[Docket No. NHTSA-2000-6940]

Anthropomorphic Test Devices; Hybrid III 5th Percentile Female Test Dummy, Alpha Version; Final Rule; Response to Petitions for Reconsideration

ACTION: Final rule; response to petitions for reconsideration.

FIGURE O1
NECK FLEXION TEST SETUP SPECIFICATIONS

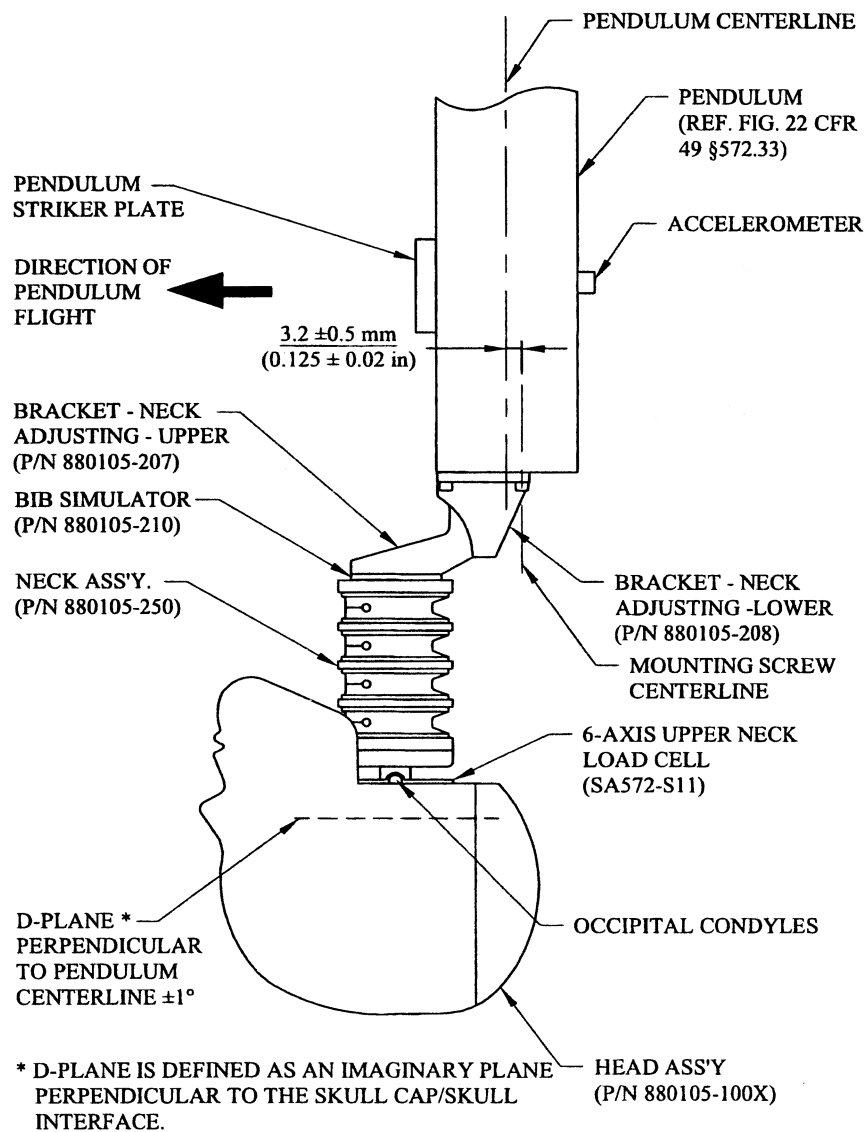
The Alliance noted that Figure O1 (*Neck Flexion Test Setup Specifications*) is missing the label for the lower neck-adjusting bracket. The Alliance also noted that the second label for the neck-adjusting bracket in Figure O2 (*Neck Extension Test Setup Specifications*) is incorrect. It should read: "BRACKET—NECK ADJUSTING—UPPER (P/N 880105-207)."

NHTSA agrees with all of these recommendations. The suggested changes reflect errors in the figures. Accordingly, the agency is revising Figure O1 by adding the missing label for the lower neck-adjusting bracket. That label will read "BRACKET—NECK ADJUSTING—LOWER (P/N 880105-208)." The agency is also revising the second label for the neck-adjusting bracket in Figure O2 to read: BRACKET—NECK ADJUSTING—UPPER (P/N 880105-207). The agency is changing the tolerance for the test probe alignment in Figure O3 from ± 0.05 degrees to ± 0.5 degrees, and the tolerance for the impact probe weight in Figures O3 and O5 from ± 0.01 kg (0.02 lb) to ± 0.023 kg (0.05 lb). Finally, the agency is adding the angle 7 ± 2 degrees from the horizontal to the note Pelvic Angle Reference Surface in Figure O3.

FIGURE 03
THORAX IMPACT TEST SETUP SPECIFICATIONS

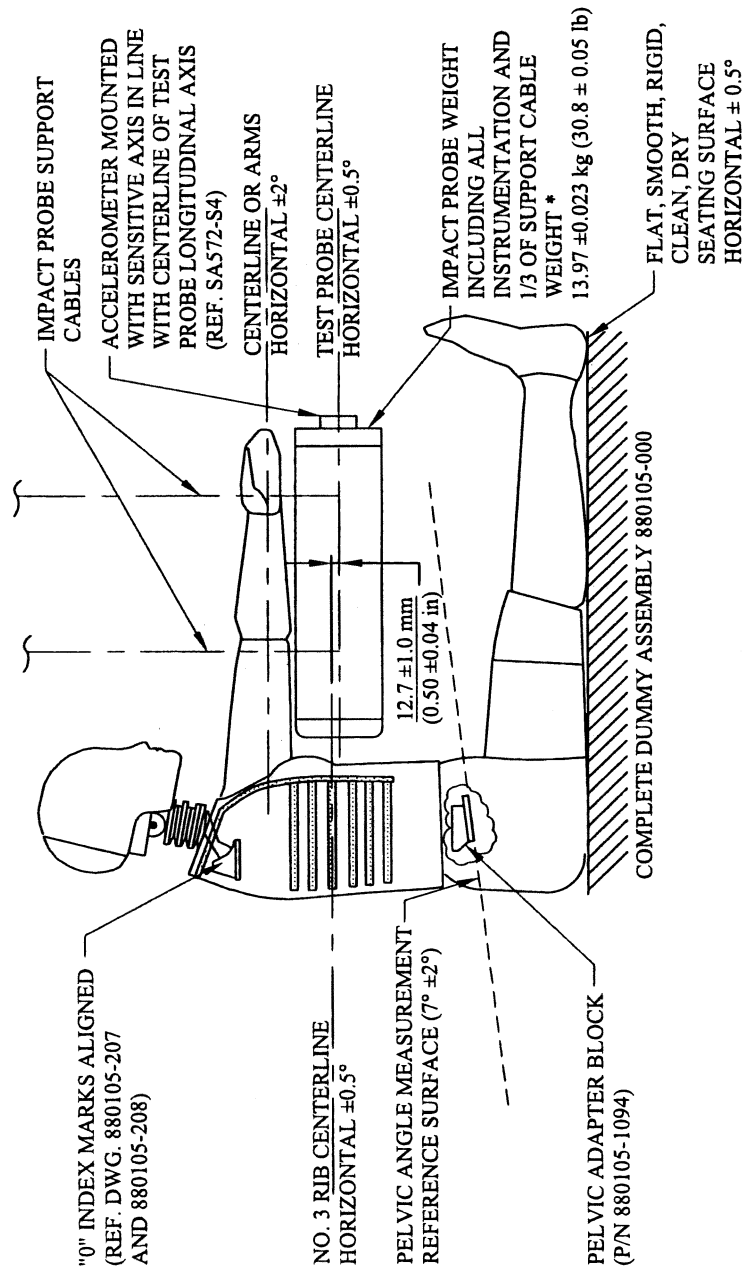
The Alliance and FTSS noted that some of the language in Figure O3 (*Thorax Impact Test Setup Specifications*) does not conform to the language in the final rule text.

Specifically, the Alliance and FTSS recommended that the agency change the tolerance for the test probe alignment from ± 0.05 degrees to ± 0.5 degrees, and the tolerance for the impact probe weight from ± 0.01 kg (0.02 lb) to ± 0.023 kg (0.05 lb) to conform to the text of the final rule. Finally, the Alliance and FTSS stated that Figure O3 does not contain a pelvic angle measurement. They noted that the Society for Automotive Engineers (SAE) Engineering Aid 25 specifies that the pelvis should be inclined rearward 7 ± 2 degrees with respect to the horizontal. They recommended that this angle be added to the note Pelvic Angle Reference Surface" in Figure O3 so that testers will not be required to force the dummy's pelvis into an unnatural orientation.

FIGURE O4
TORSO FLEXION TEST SET UP SPECIFICATIONS

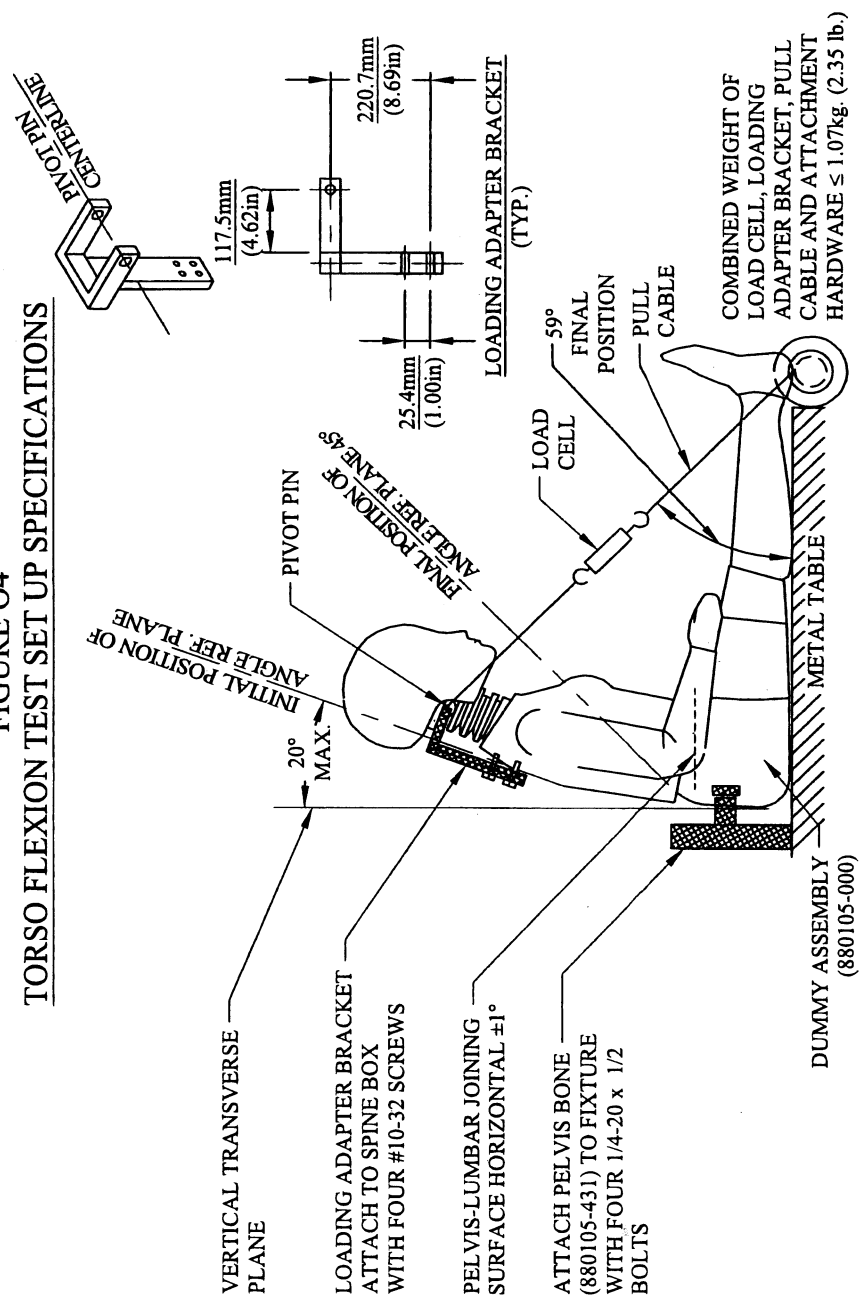
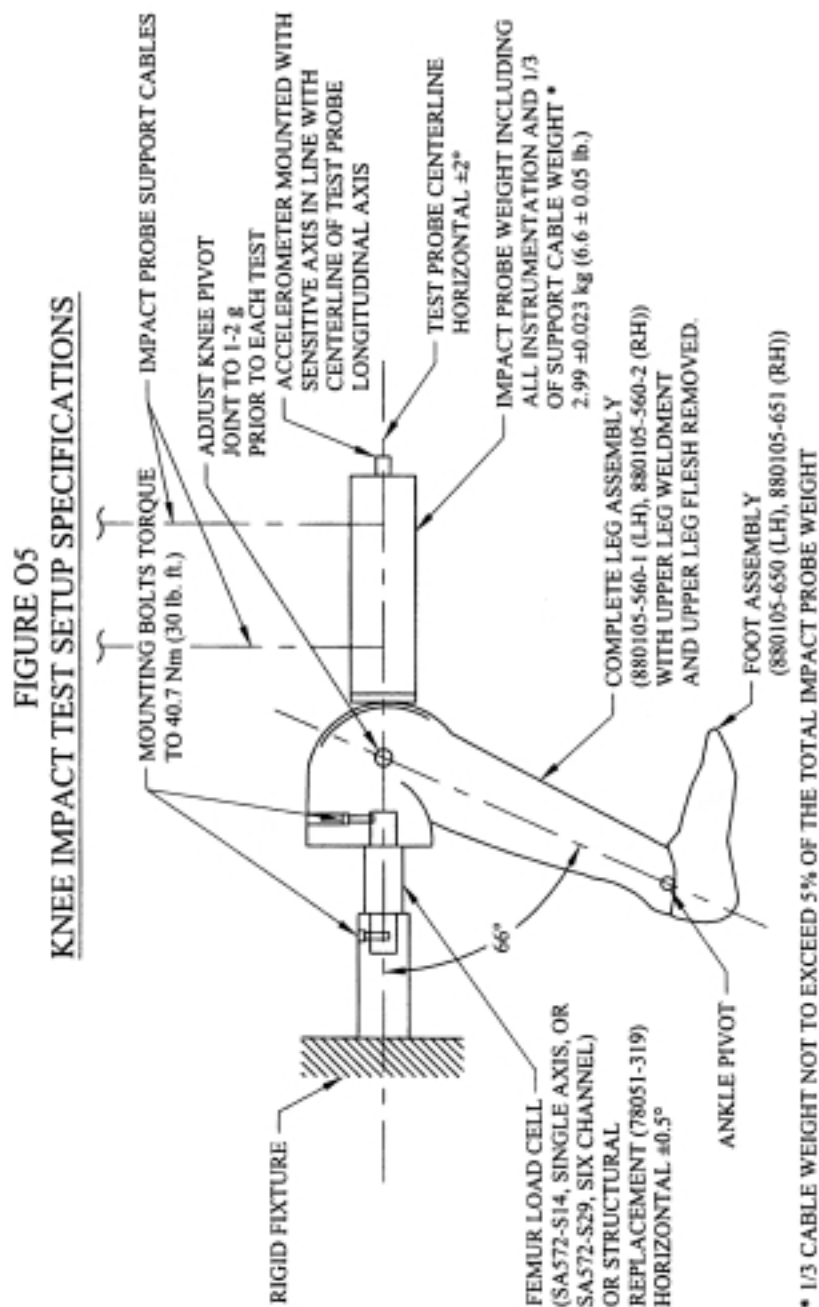
In reviewing Figure O4, NHTSA discovered that it had failed to specify the weight of the pull mechanism⁷ used in the torso flexion test. The Hybrid III Six- and Three-Year-Old dummy requirements each specify the weight of the pull mechanism for the torso flexion test. To be consistent with those dummy requirements and assure test repeatability, the agency is specifying that the weight of the pull mechanism must be less than or equal to 1.07 kg (2.35 lb).

Accordingly, the agency is adding the following note to Figure O4: "Combined weight of load cell, loading adaptor bracket, pull cable, and attachment hardware 1.07 kg (2.35 lb)."
